D49 TRANSPORTATION CENTER
SCHOOL DISTRICT NO 49
11971 SWINGLINE ROAD
PEYTON, CO 80831

SHEET TITLE
**OVERALL
HORIZONTAL
CONTROL PLAN**

ISSUED FOR
**CONSTRUCTION
DOCUMENTS**

Sign Plan_V1.pdf Markup Summary

C3.0

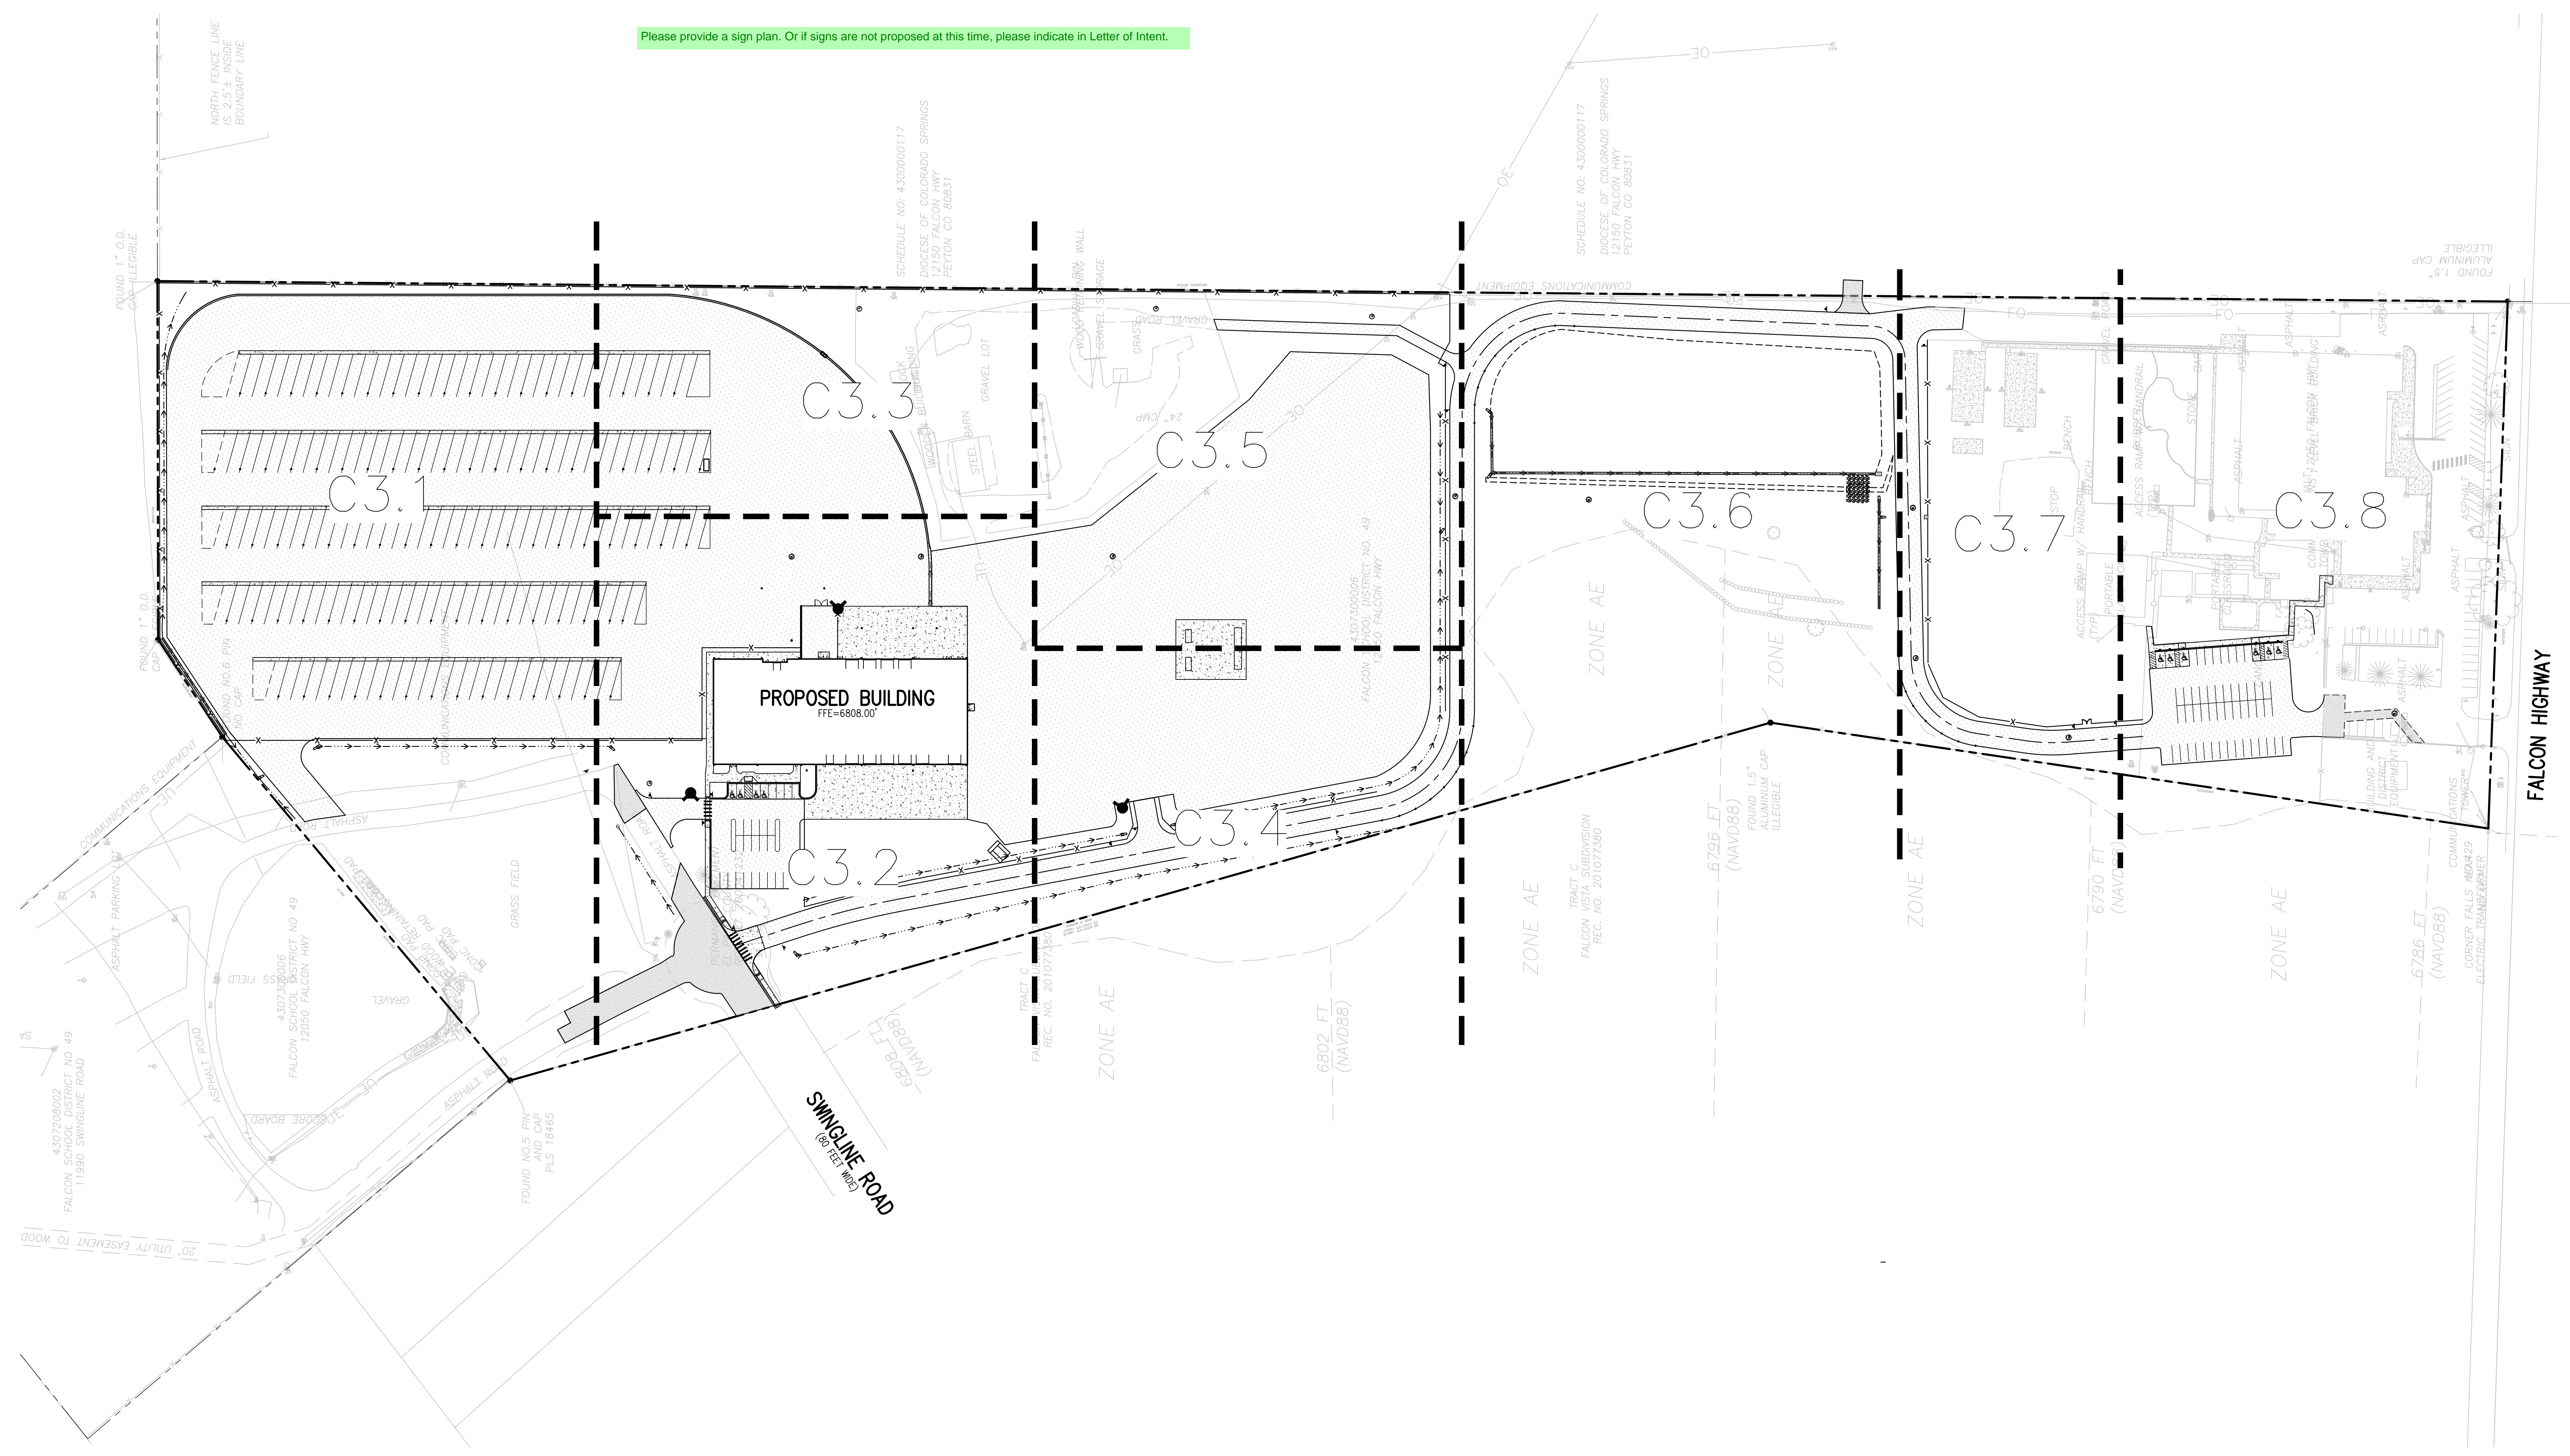
Please provide a sign plan. Or if signs are not proposed at this time, please indicate in Letter of Intent.
